Fargo VAMC – Refurbish Elevators and Replace Controls

Fargo, North Dakota
Project #19-2481

MARCH 26, 2024

ADDENDUM NO. 2

EXISTING 2 HOUR FIRE RATED PARTITION

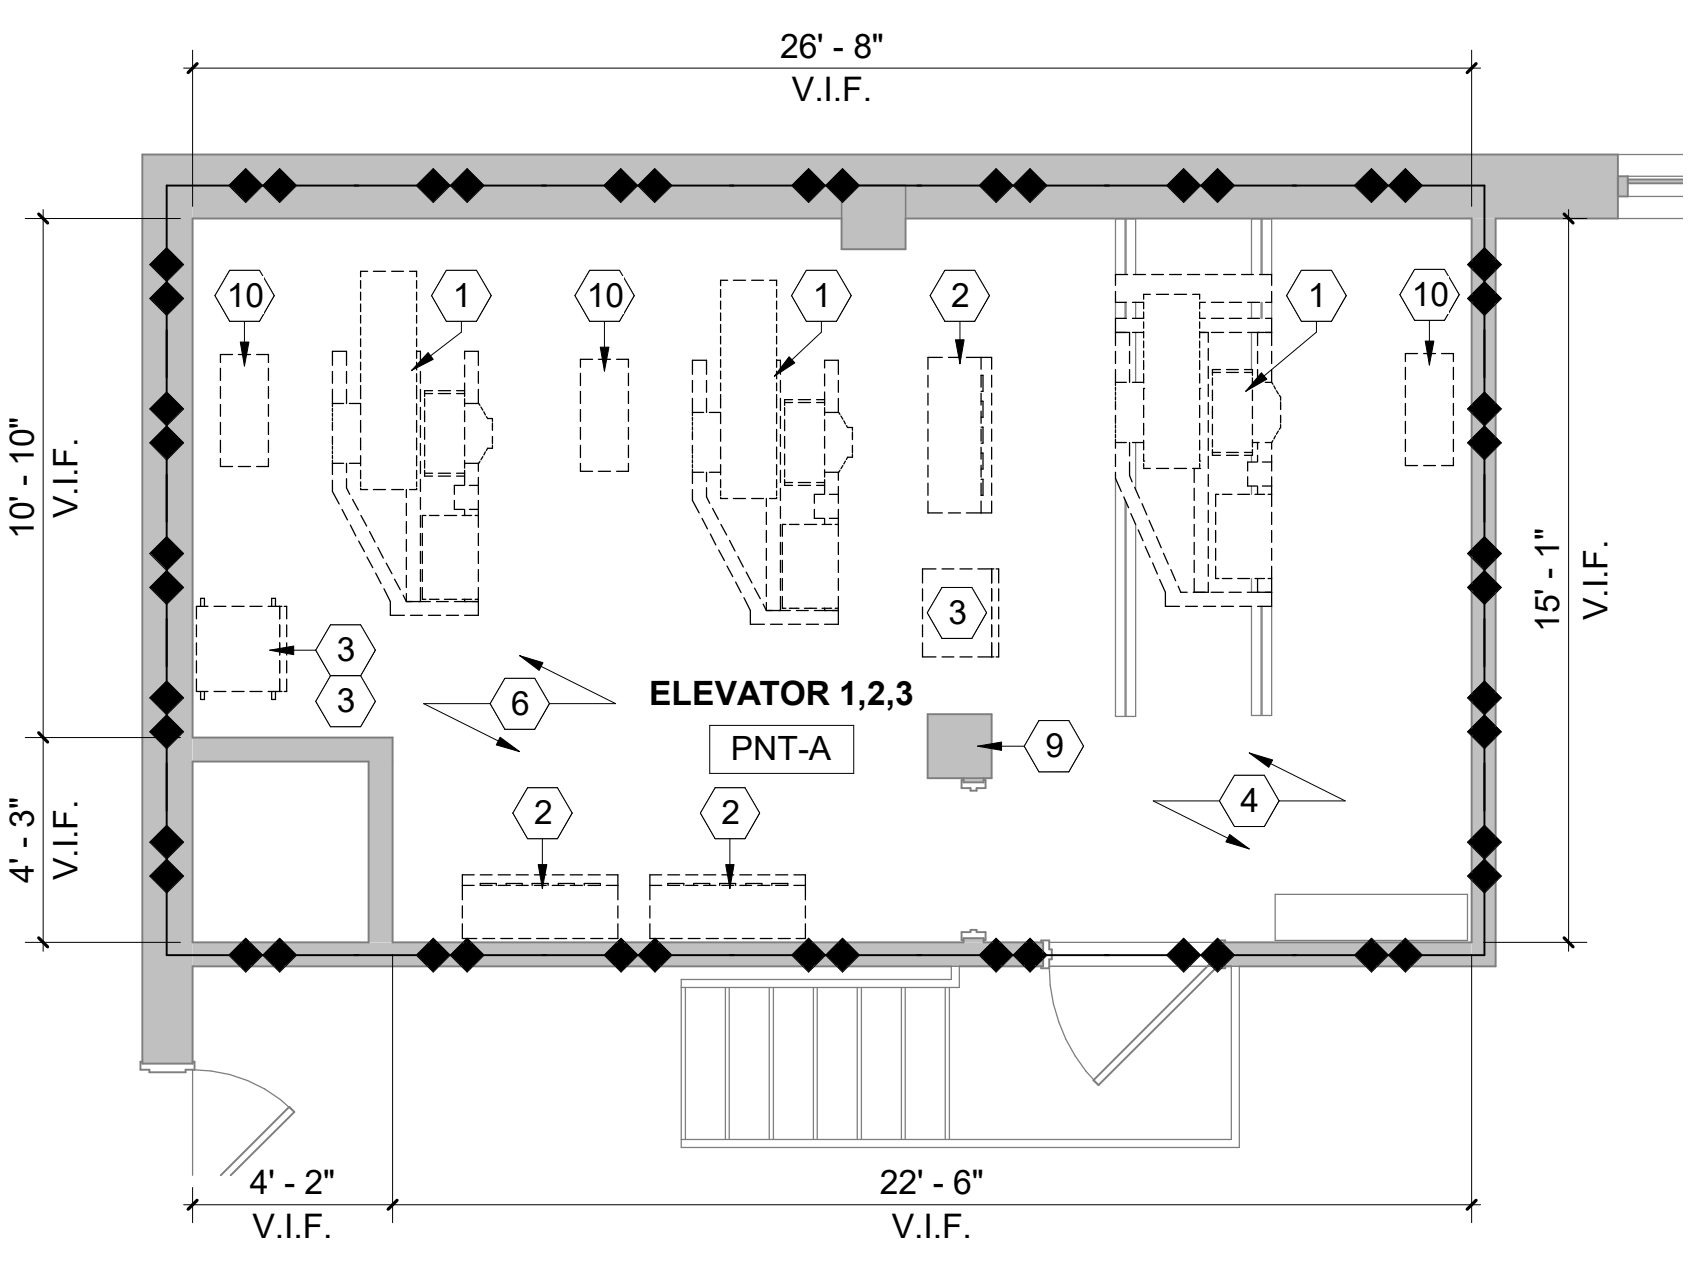
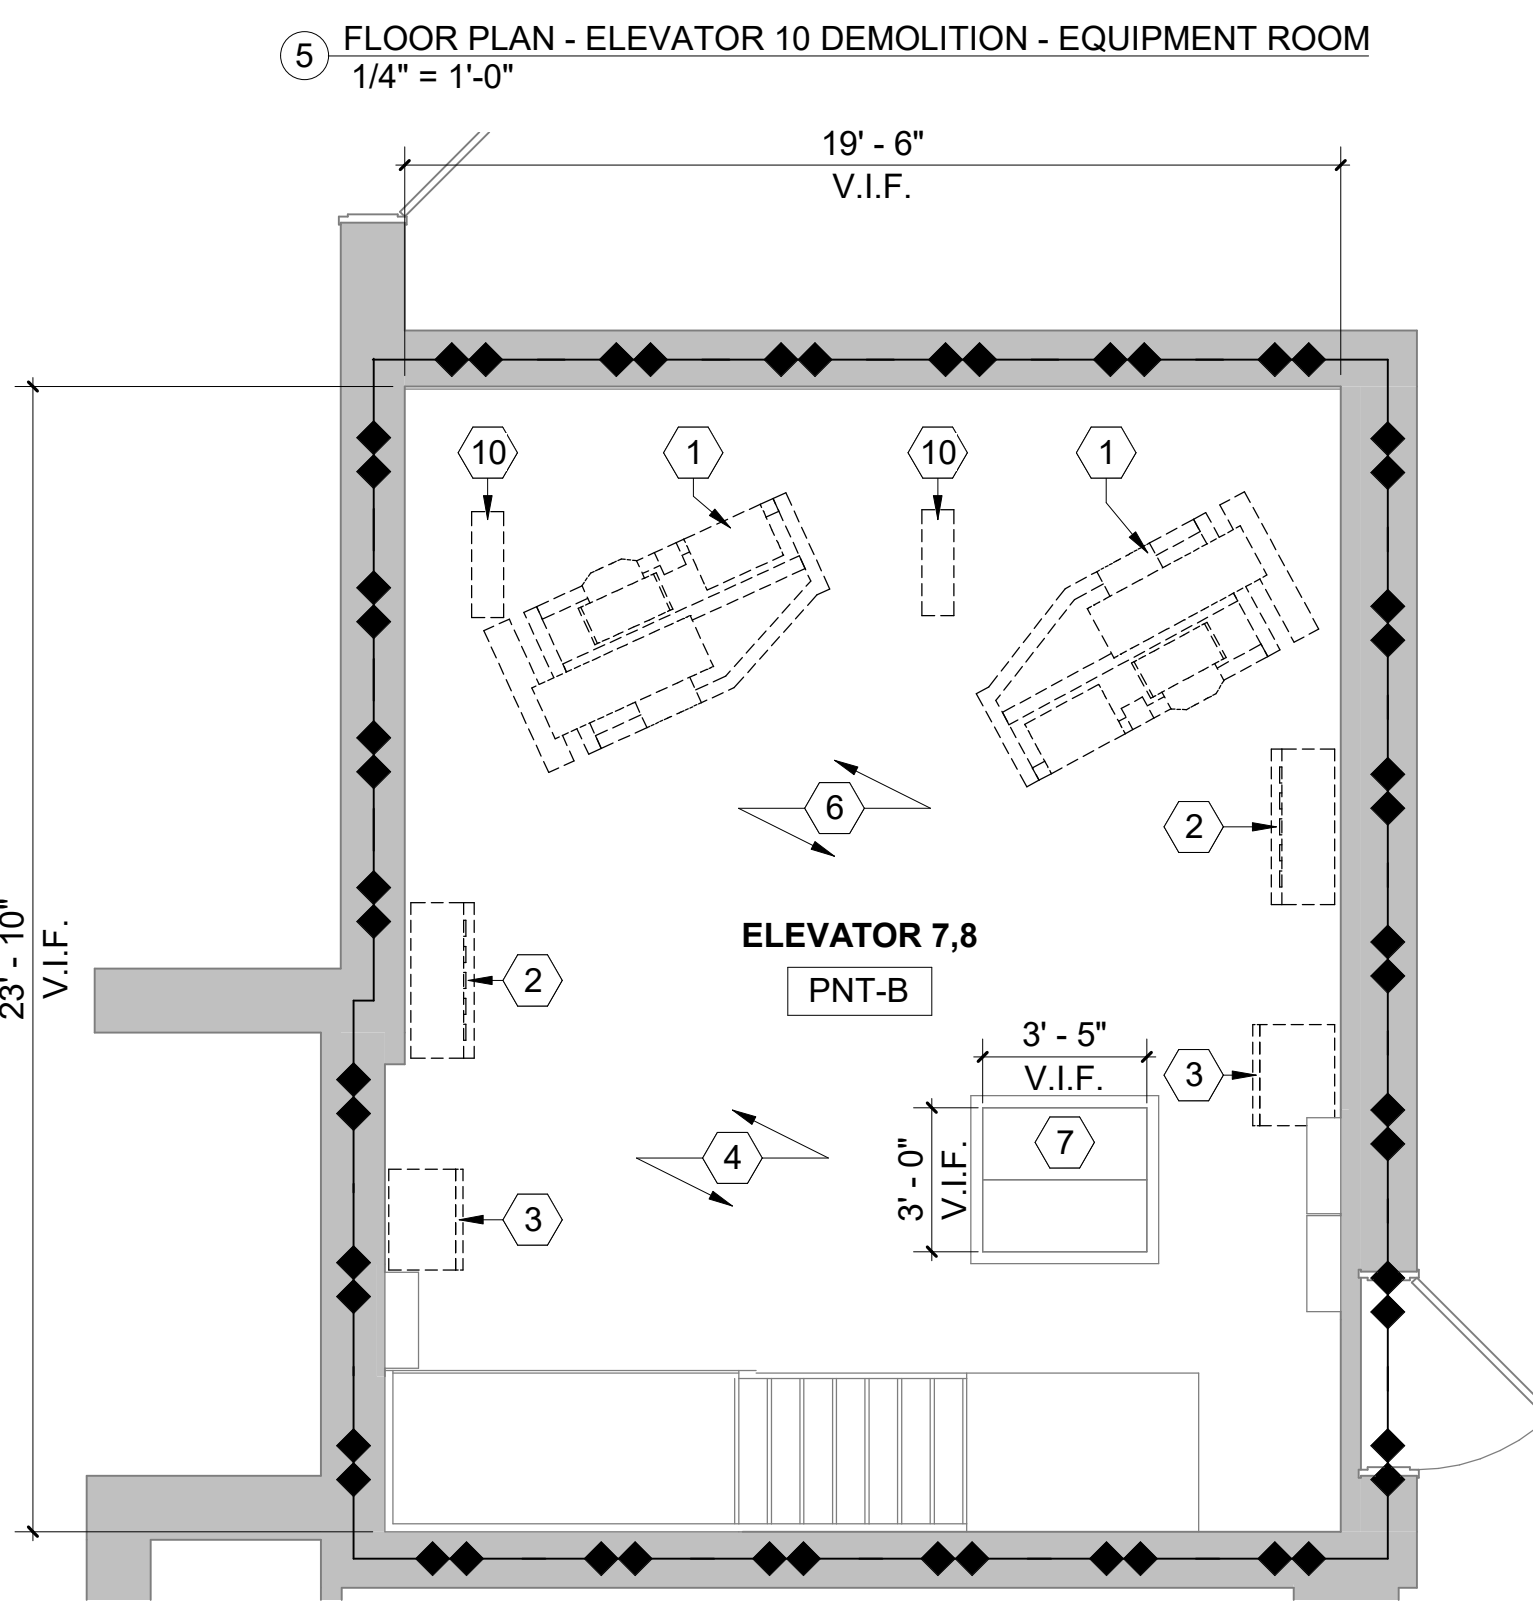
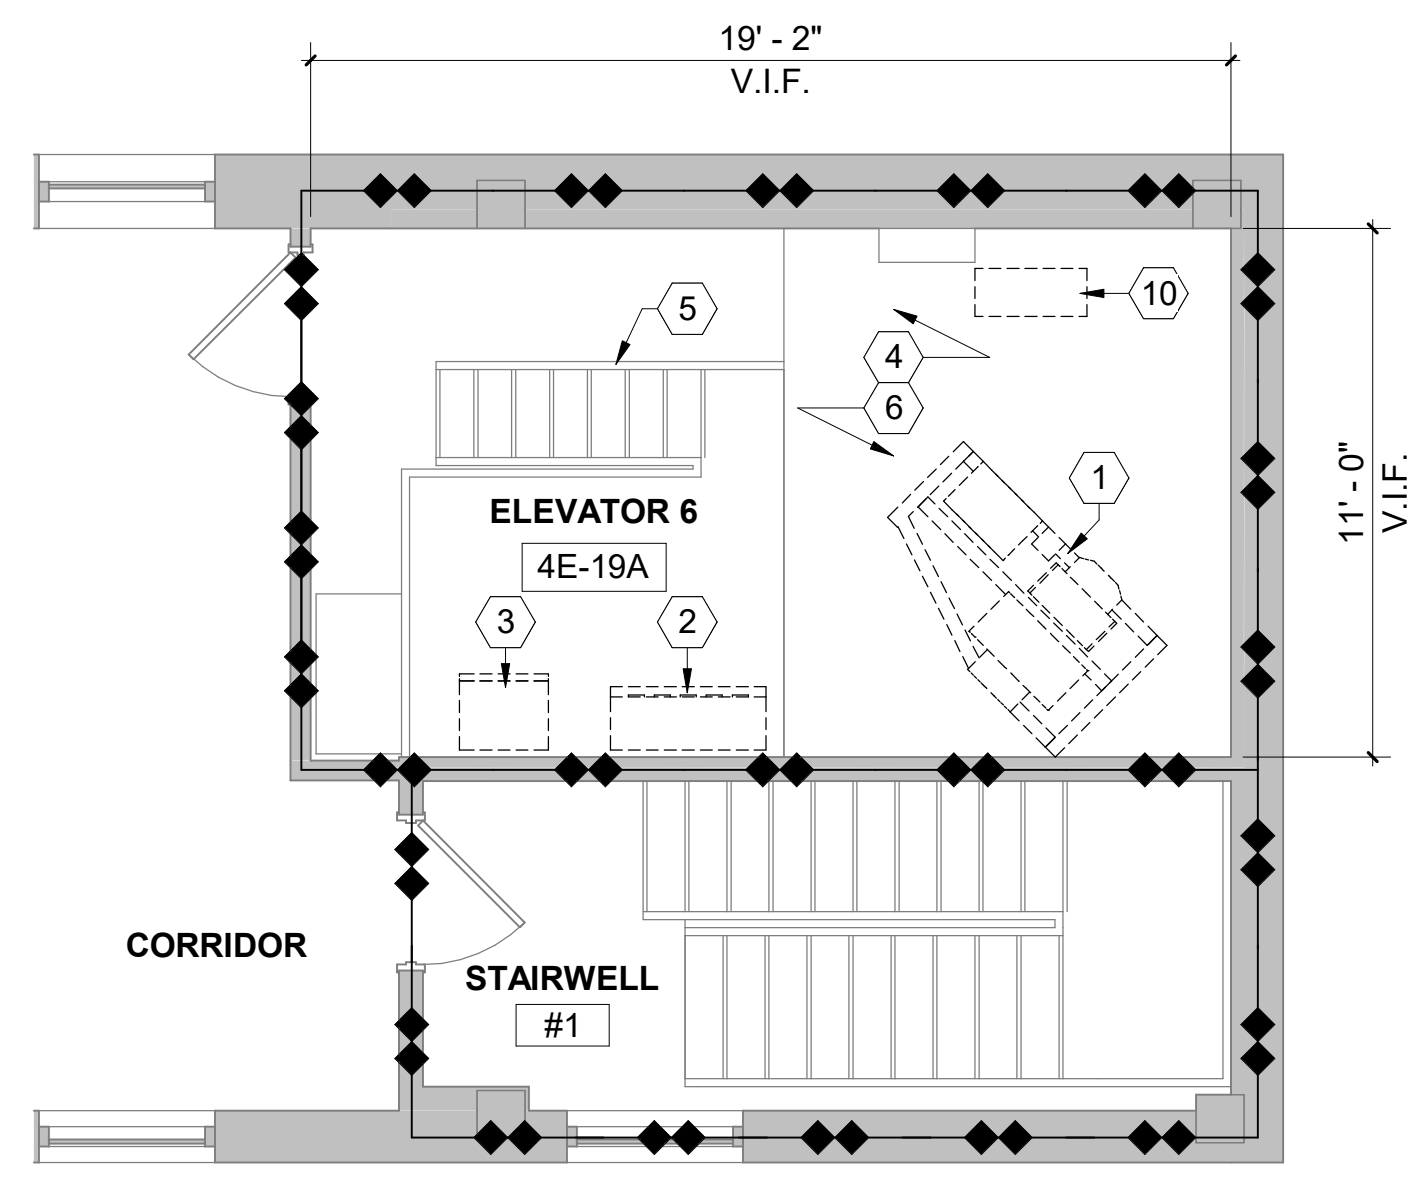
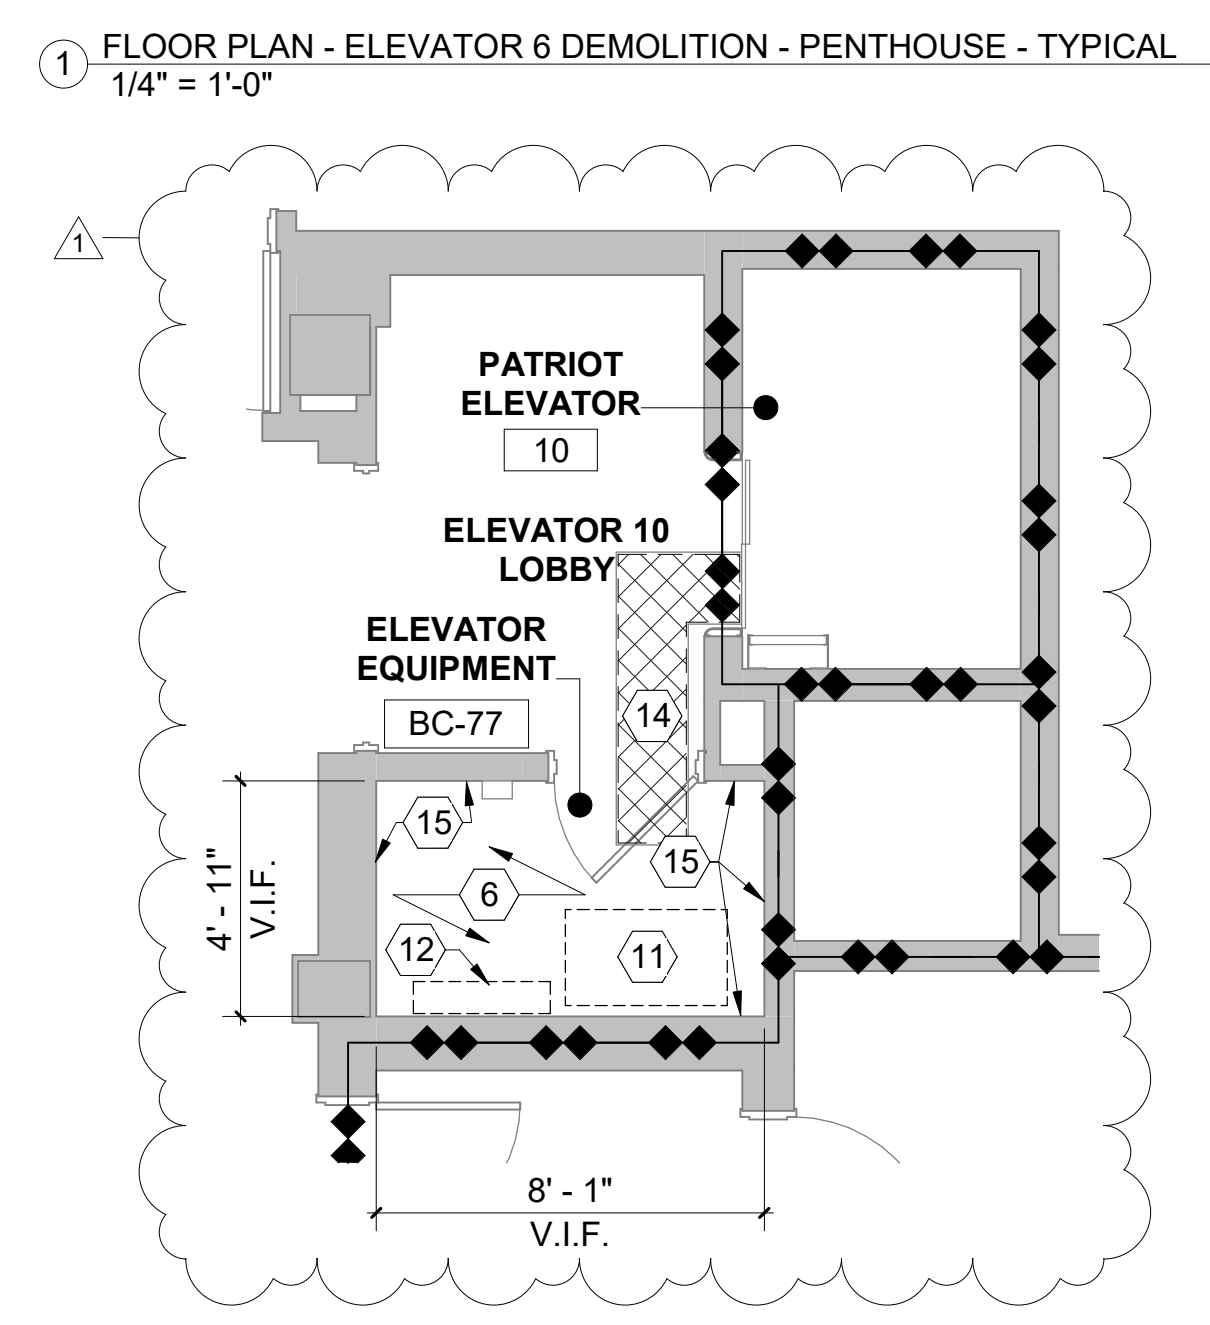
Drawing Sheet AD5.22 ENLARGED PLANS – PENTHOUSE / EQUIPMENT ROOMS - DEMOLITION – See revised drawing sheet for the adjustment of keynotes # 1.
